UNITED STATES PATENT AND TRADEMARK OFFICE

Office Action Summary

10/801,634

MIZUTANI, MASASHI

Fig.8

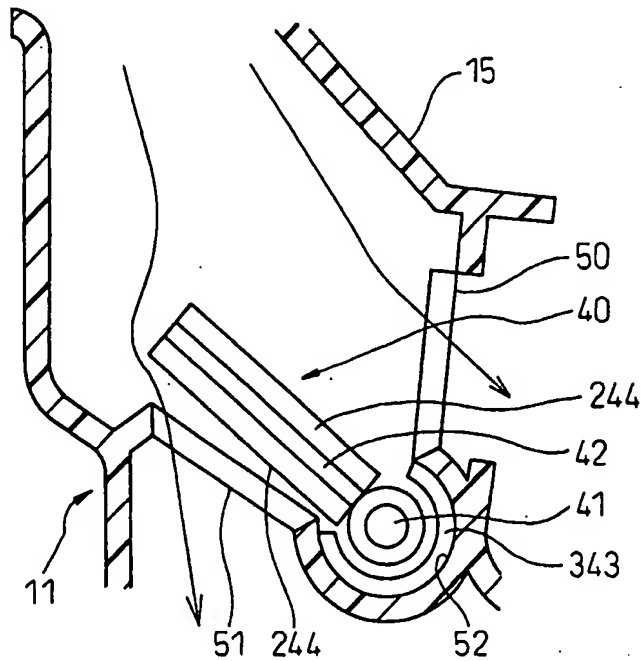
4. The replacement drawings corresponding to Figures 8 and 9 were received on April 3, 2007. These replacement drawings are hereby approved.
5. Upon reconsideration, the drawings filed on 16 March 2004 are objected to under 37 CFR 1.83(a). The drawings must show every feature of the invention specified in the claims. Therefore, the following features must be shown or the feature(s) canceled from the claim(s): a device for opening and closing a passage provided with both a small diameter shaft portion and a large diameter shaft portion with a packing member disposed between the shaft and the bearing hole of a case wherein the packing member is further ONLY attached to the small diameter portion of the shaft as recited in claim 2. No new matter should be entered.
